August 17, 2017
GO2-17-147

Subject: **COLUMBIA GENERATING STATION, DOCKET NO. 50-397
ENERGY NORTHWEST'S NOTIFICATION OF FULL COMPLIANCE WITH
ORDER EA-12-049, "ORDER MODIFYING LICENSES WITH REGARD TO
REQUIREMENTS FOR MITIGATION STRATEGIES FOR BEYOND DESIGN
BASIS EXTERNAL EVENTS"**

**FINAL INTEGRATED PLAN FOR THE MITIGATION OF BEYOND-
DESIGN-BASIS EXTERNAL EVENTS**

RAI No.2

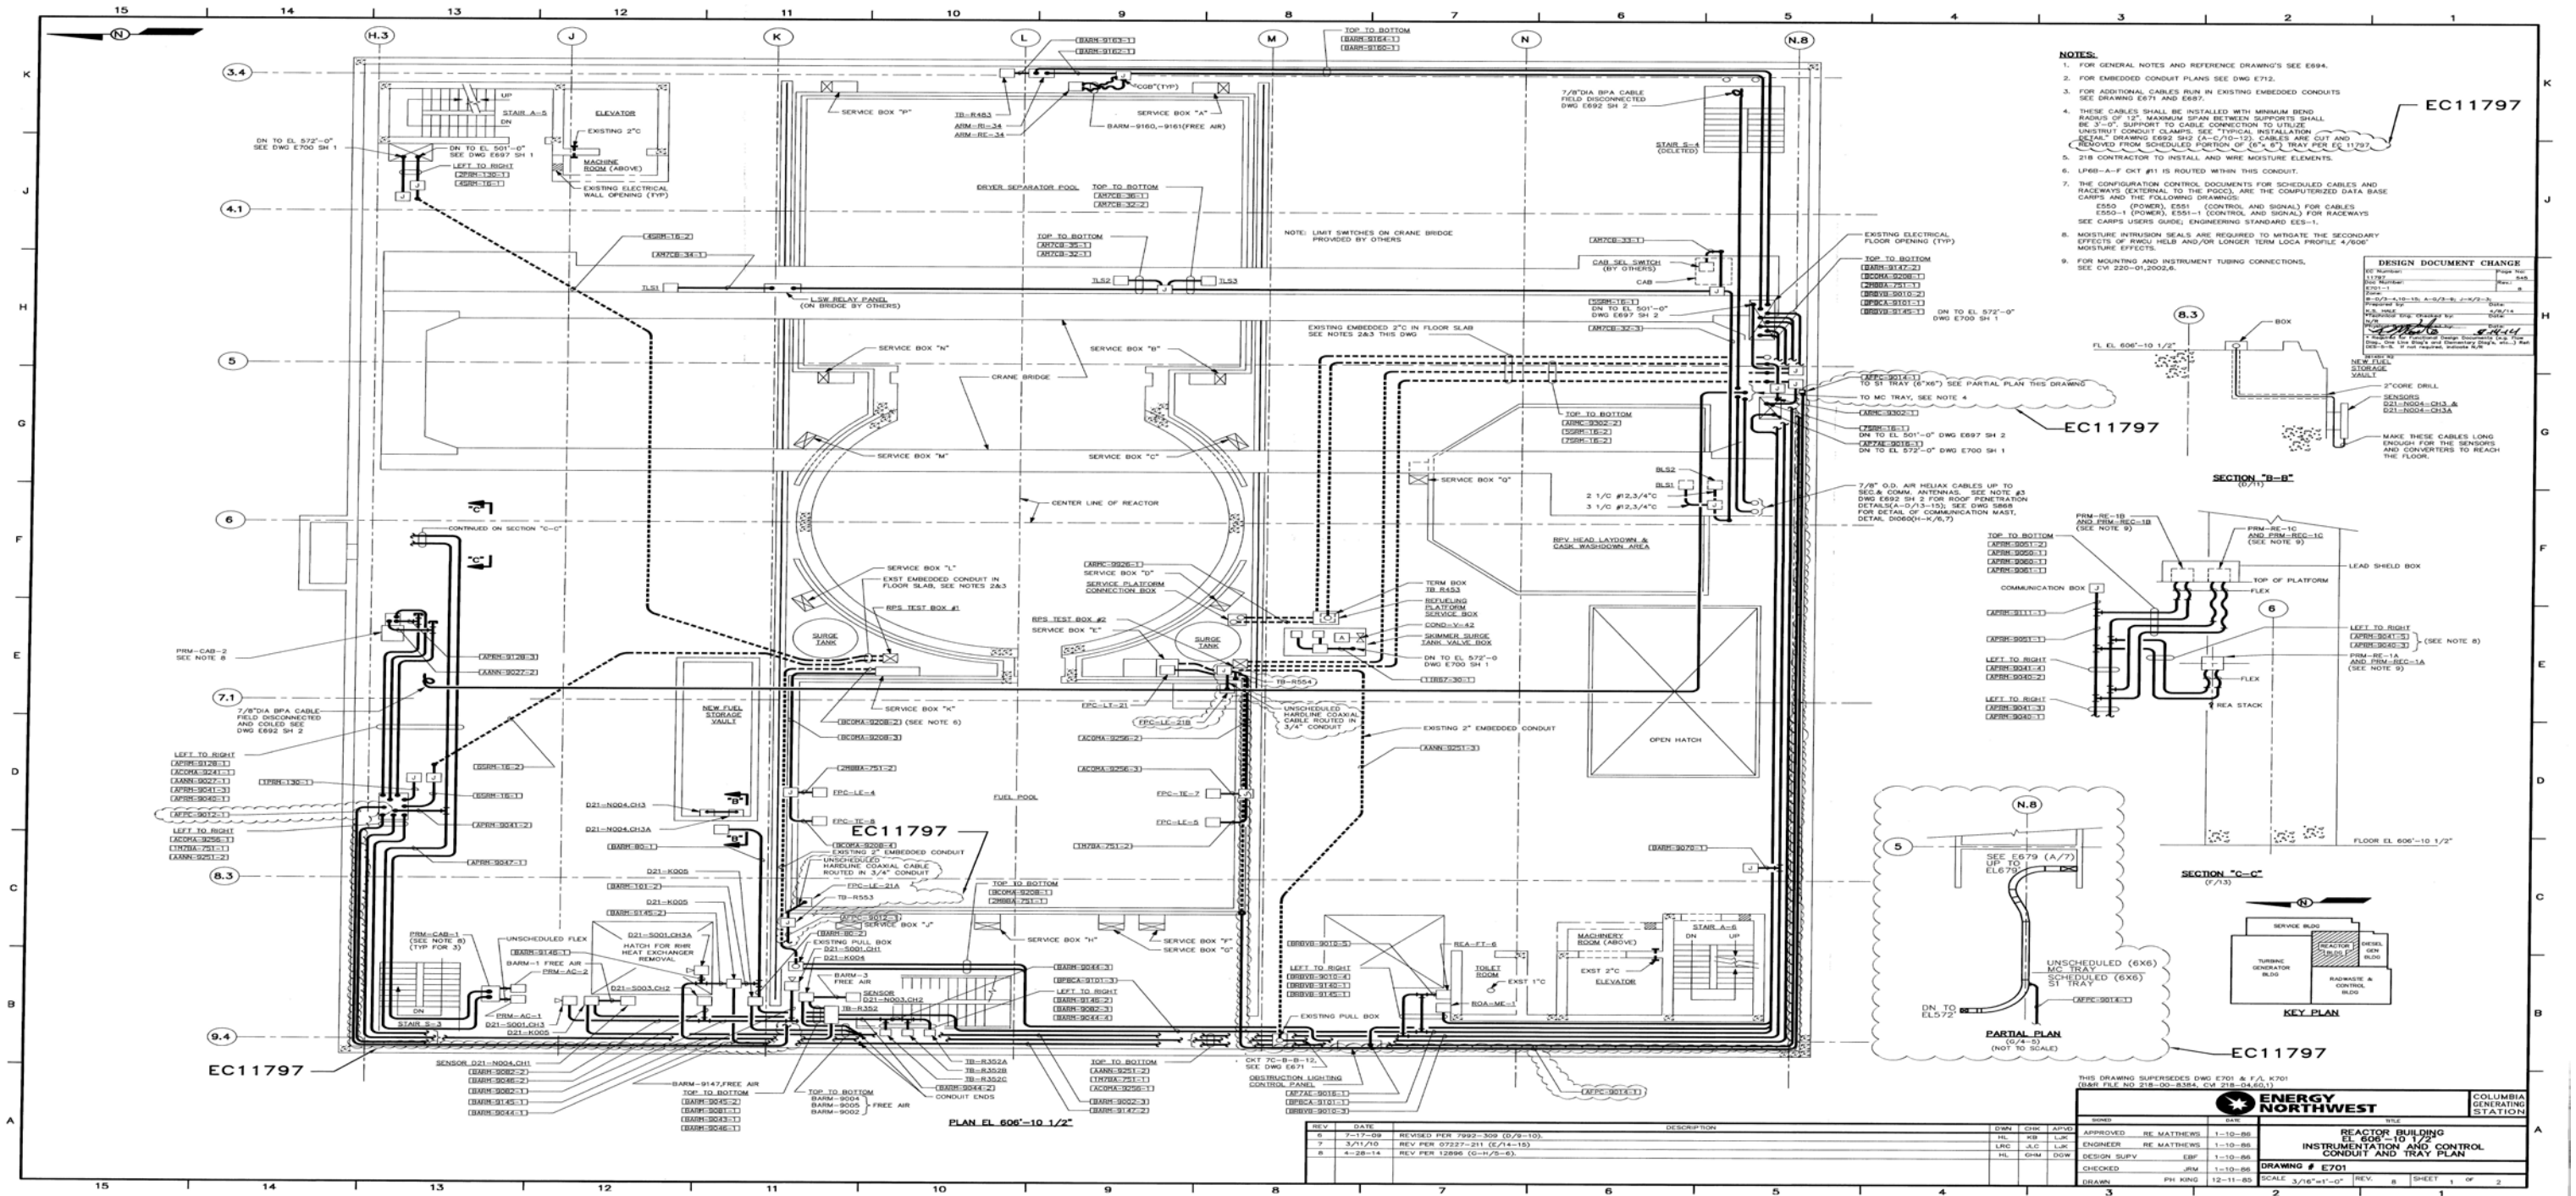
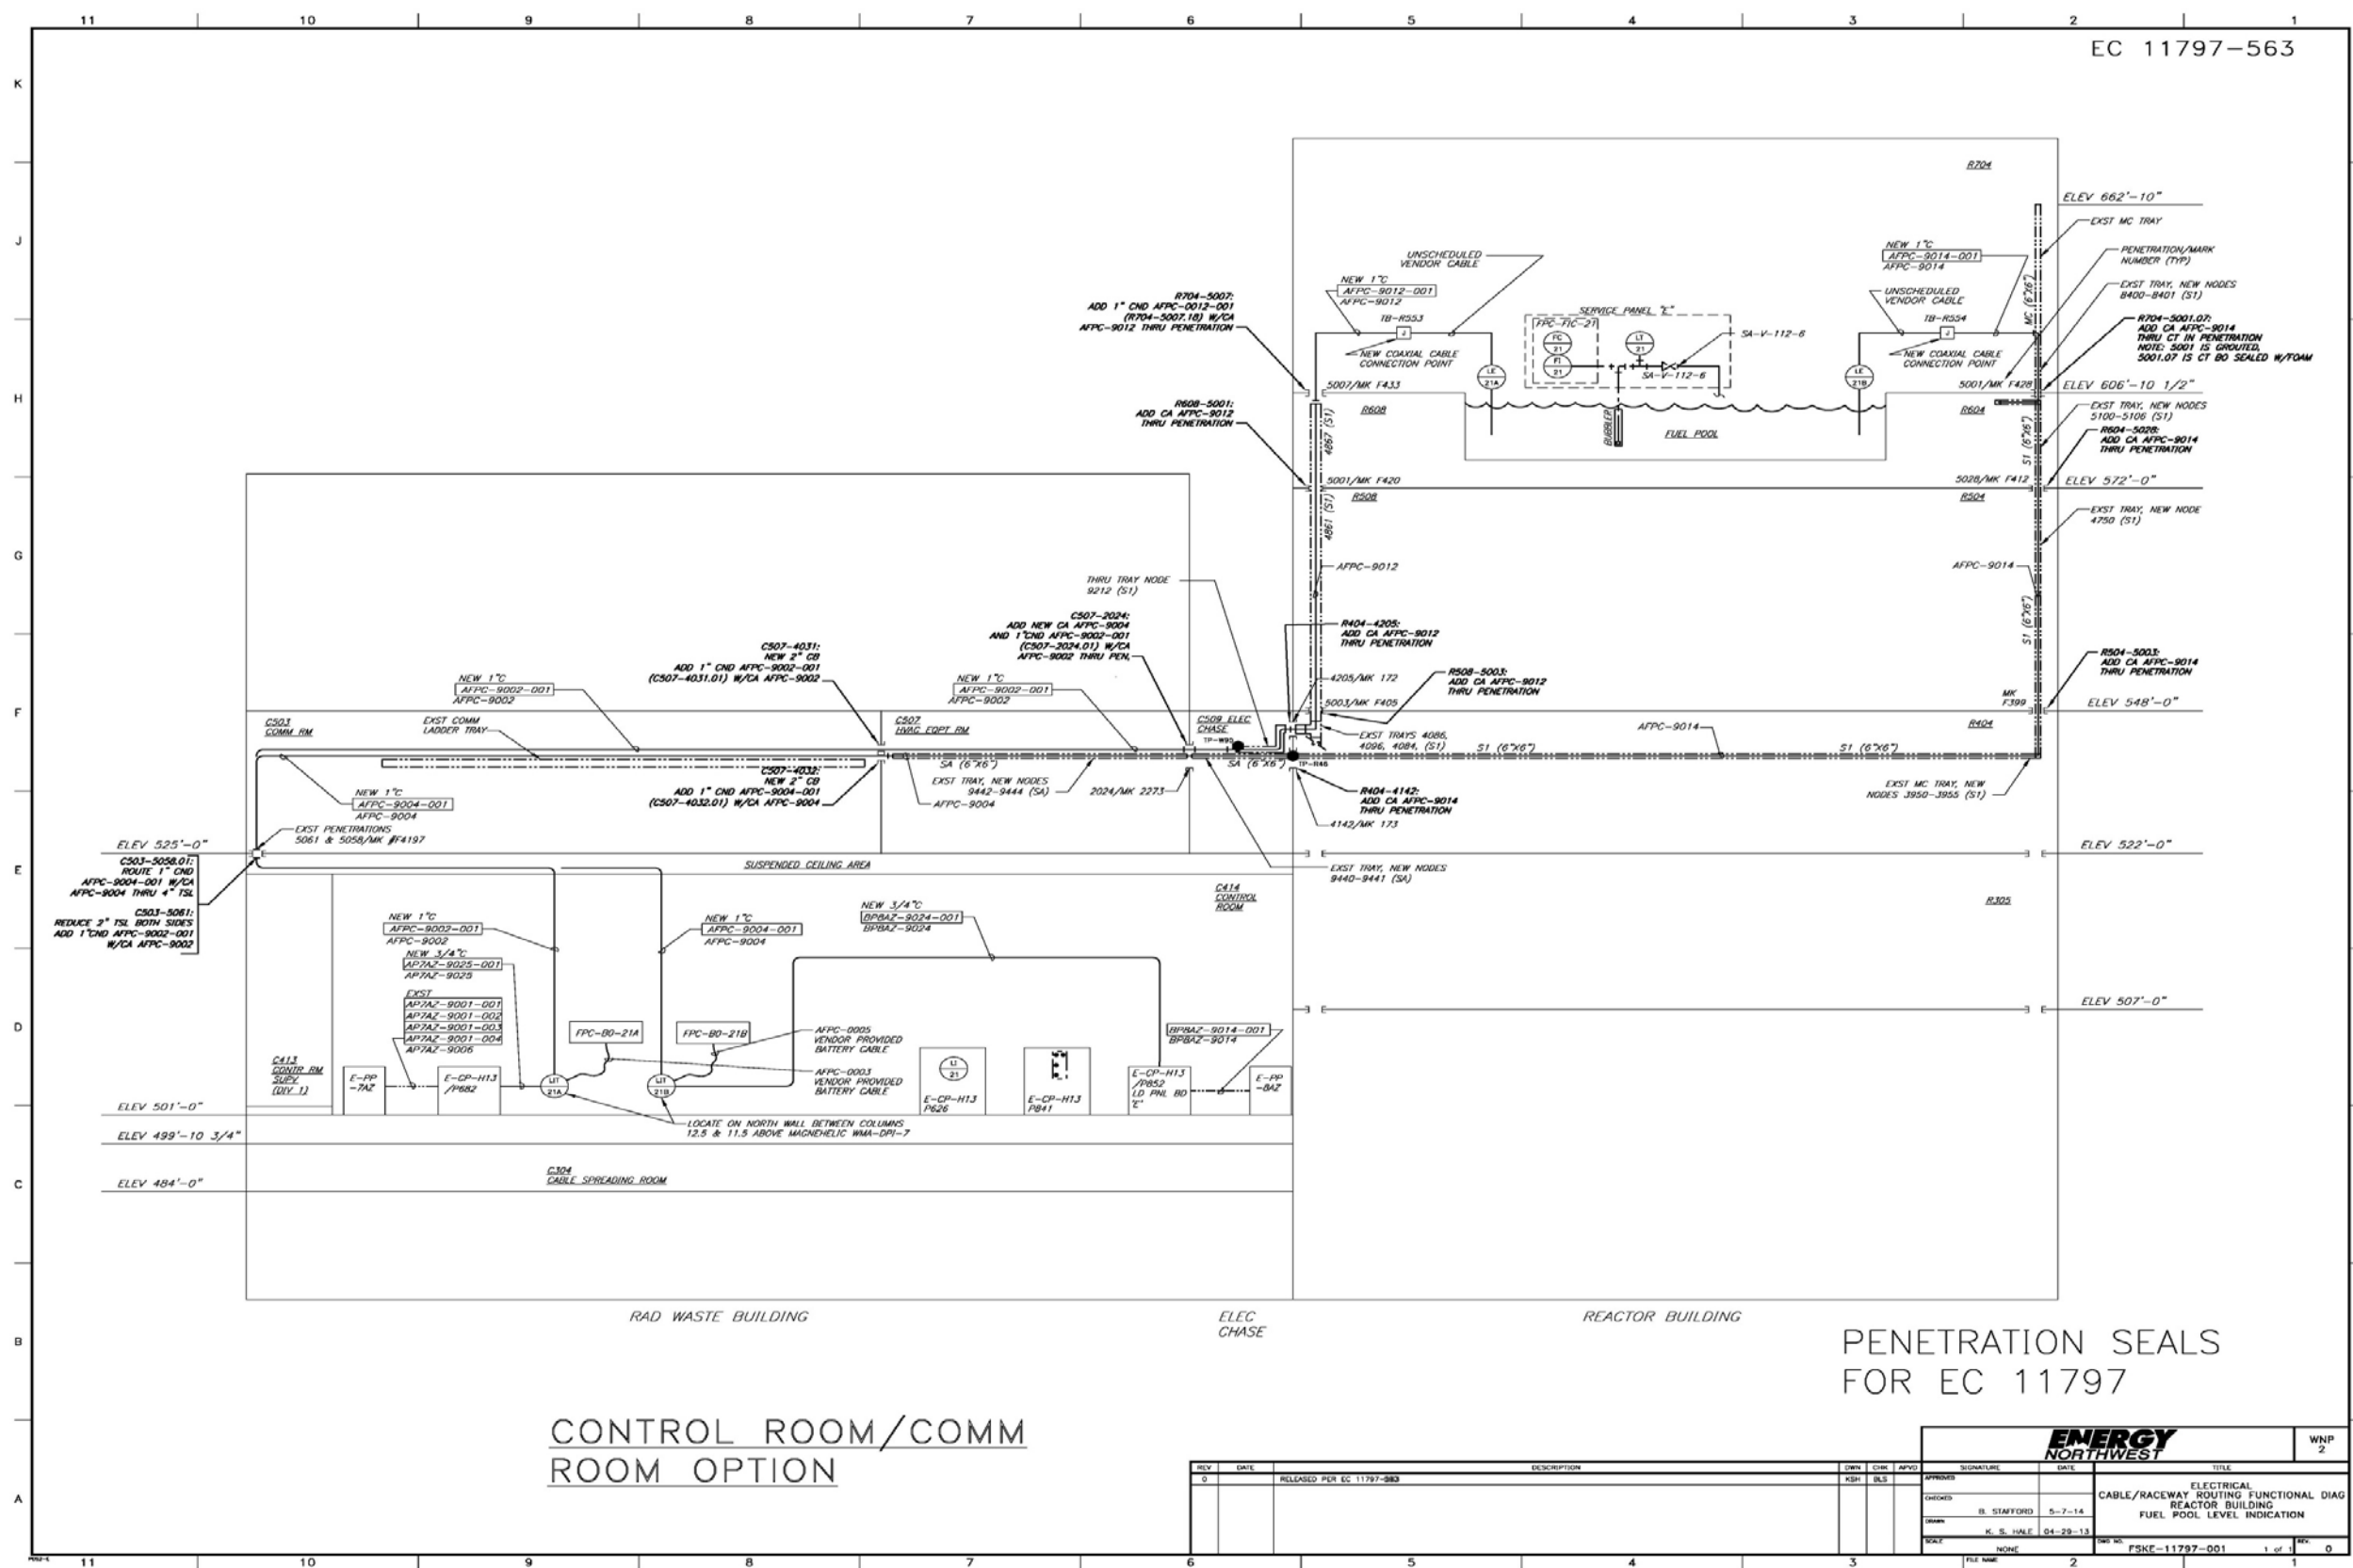
- a) A clearly labeled sketch or marked-up plant drawing of the plan view of the SFP area, depicting the SFP inside dimensions, the planned locations/placement of the primary and back-up SFP level sensor, and the proposed routing of the cables that will extend from the sensors toward the location of the read-out/display device to meet the Order requirement to provide reasonable protection of the level indication function against missiles that may result from damage to the structure over the SFP.
- b) Please address how other hardware stored in the SFP will not create adverse interaction with the fixed instrument location(s).

- a) Sketches are provided below.

RAI No. 11

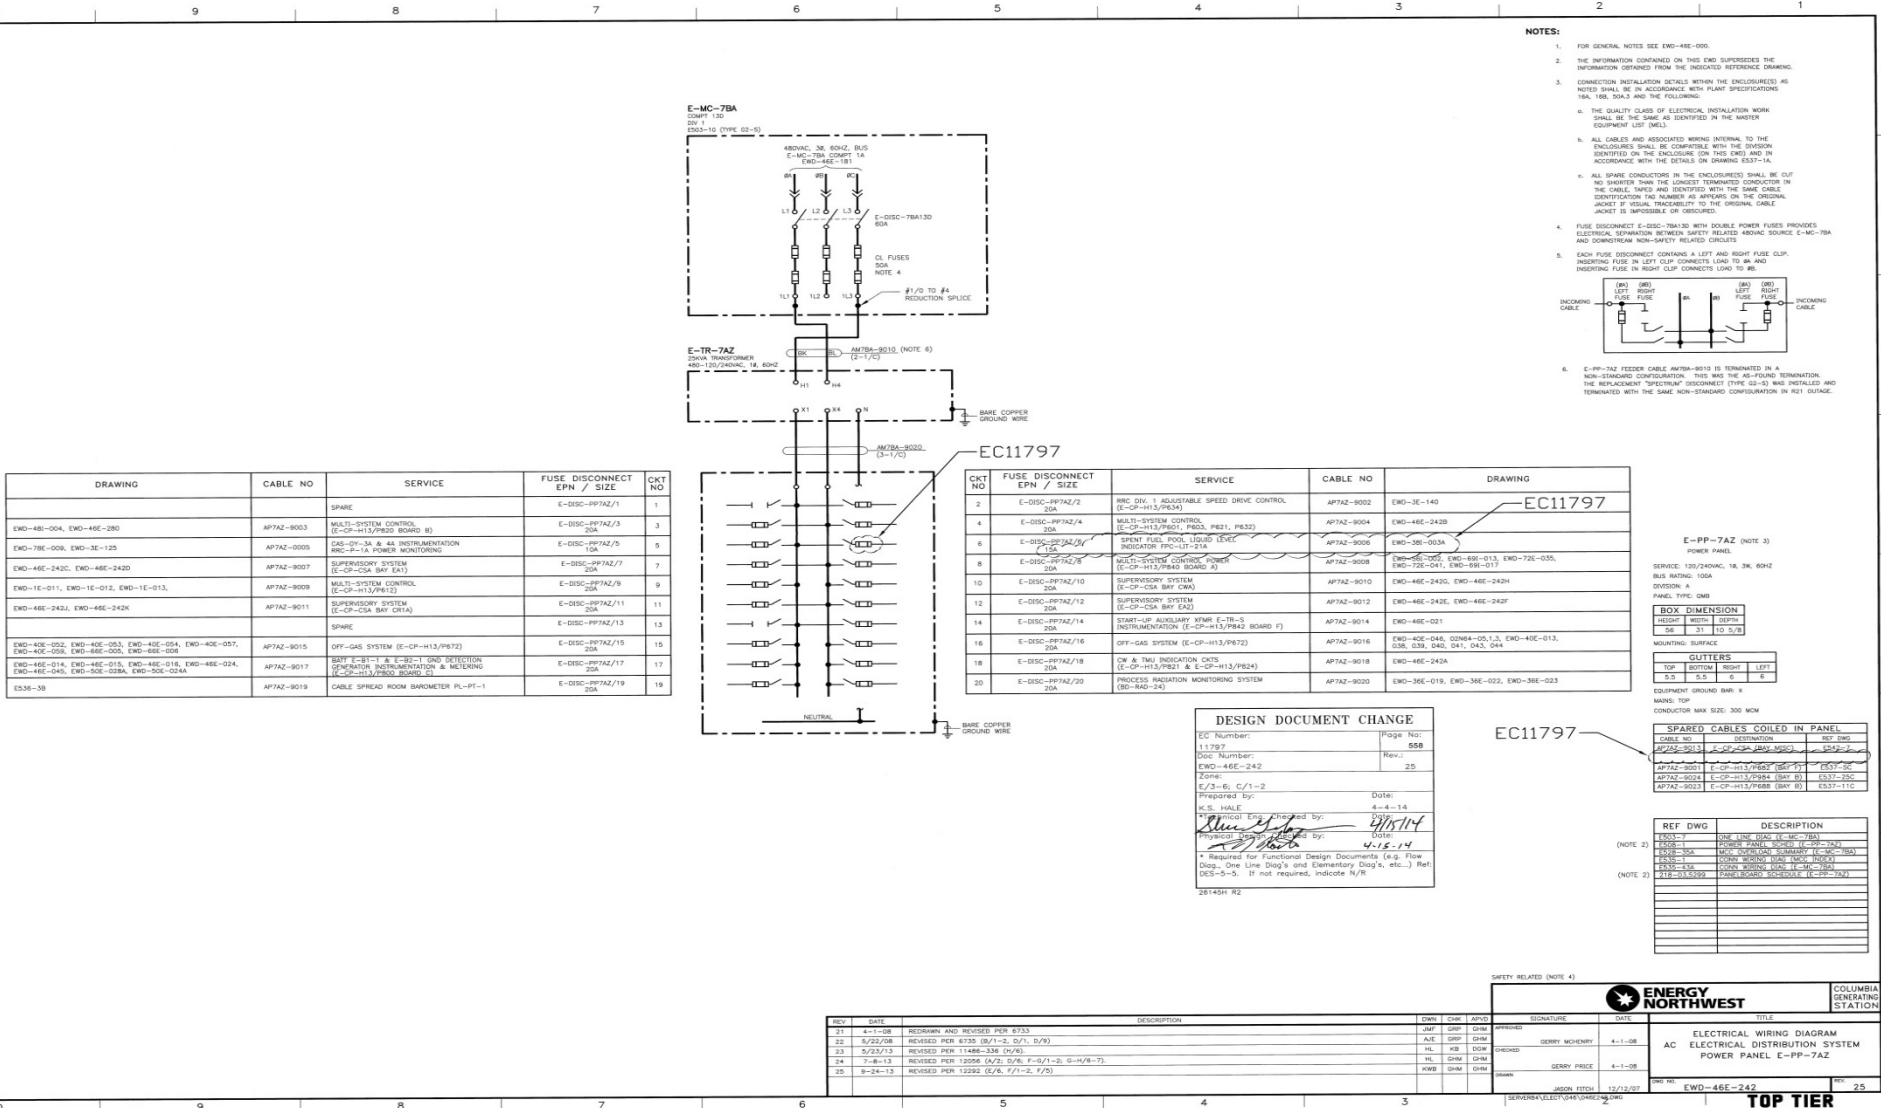
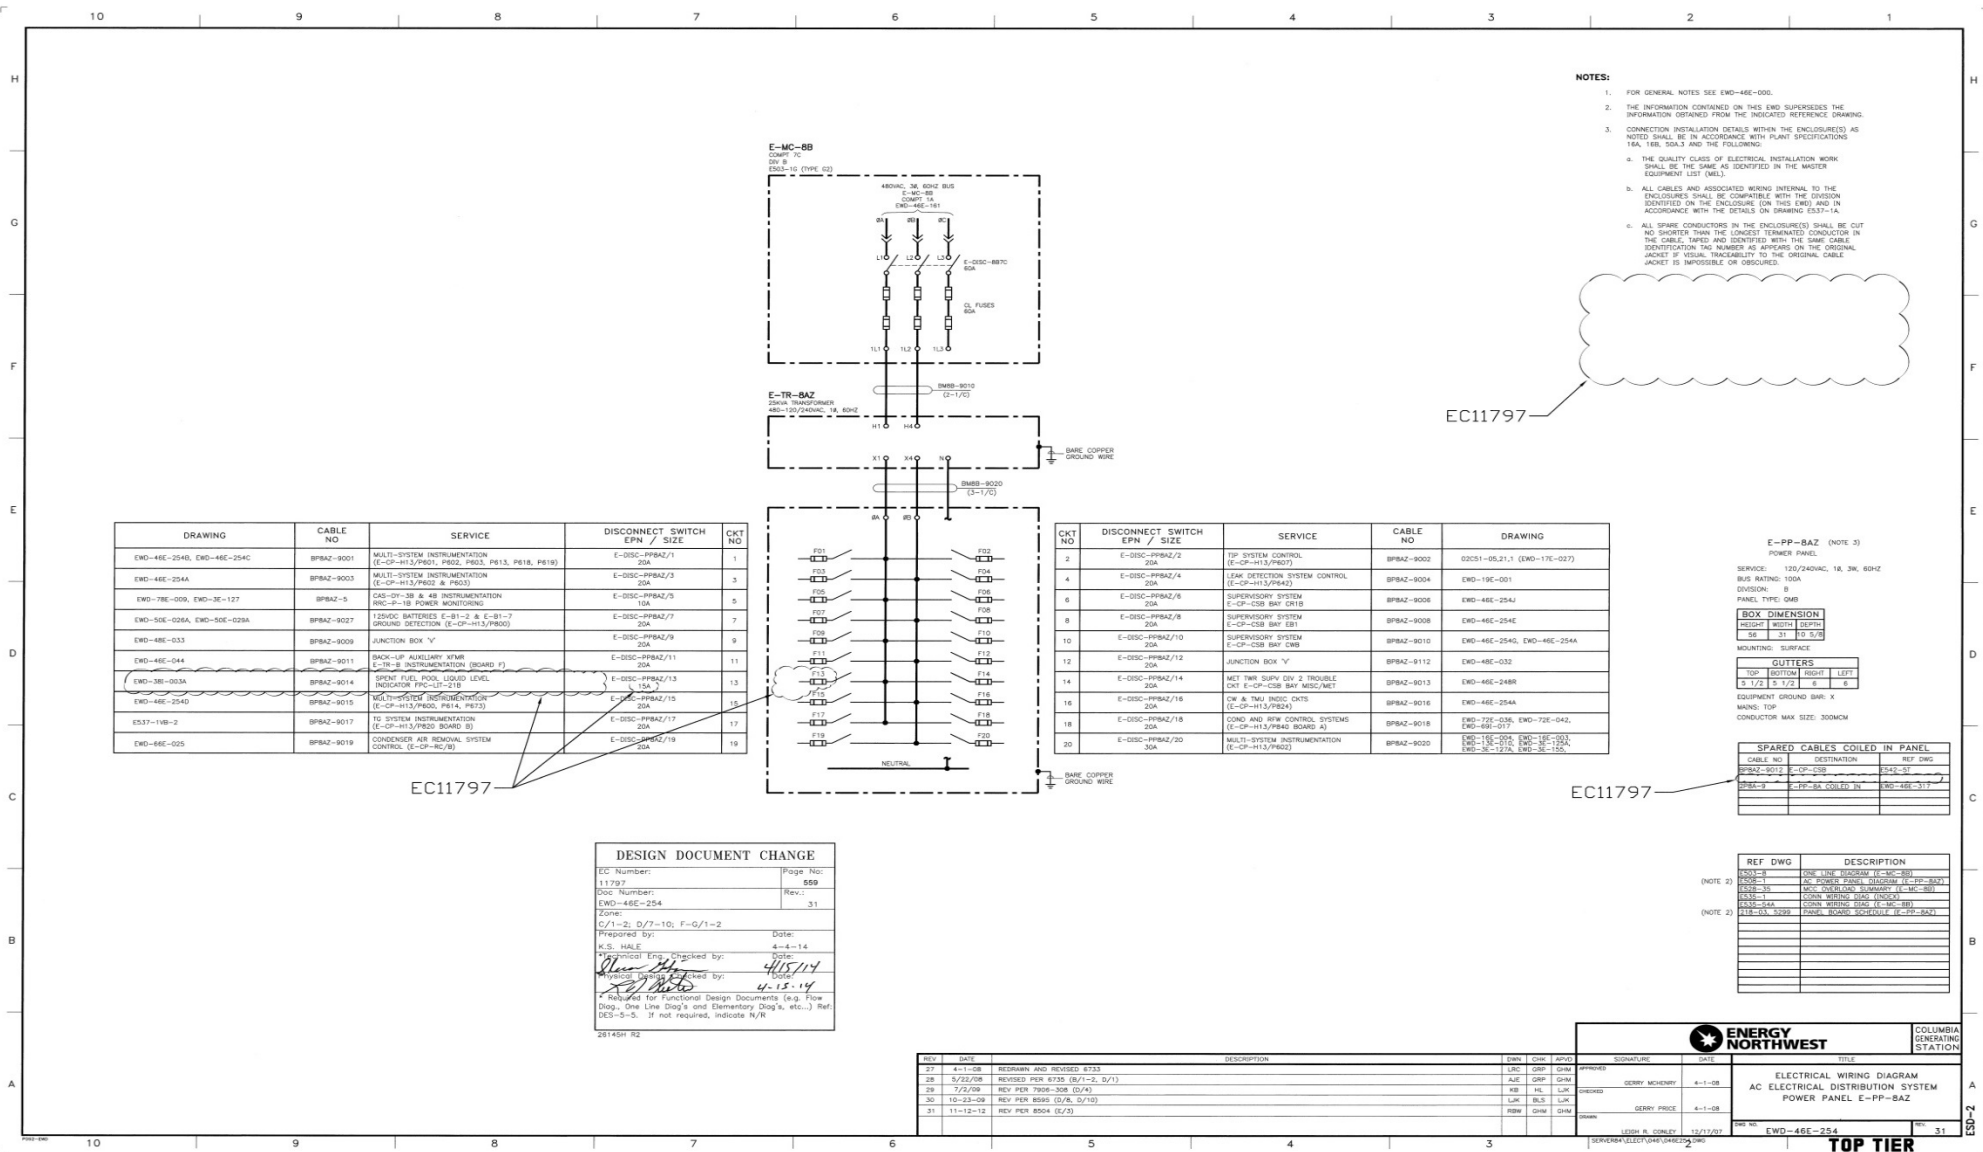
Please provide the NRC staff with the final configuration of the power supply source for each channel so that the staff may conclude that the two channels are independent from a power supply assignment perspective.

Each SFP instrument channel is normally powered from a 120/240-V ac 60 Hz plant distribution panel to support continuous monitoring of SFP level. The primary channel will receive power from a different 480V bus than the backup channel. Therefore, loss of any one 480-V ac bus does not result in loss of normal 120-V ac power for both instrument channels.
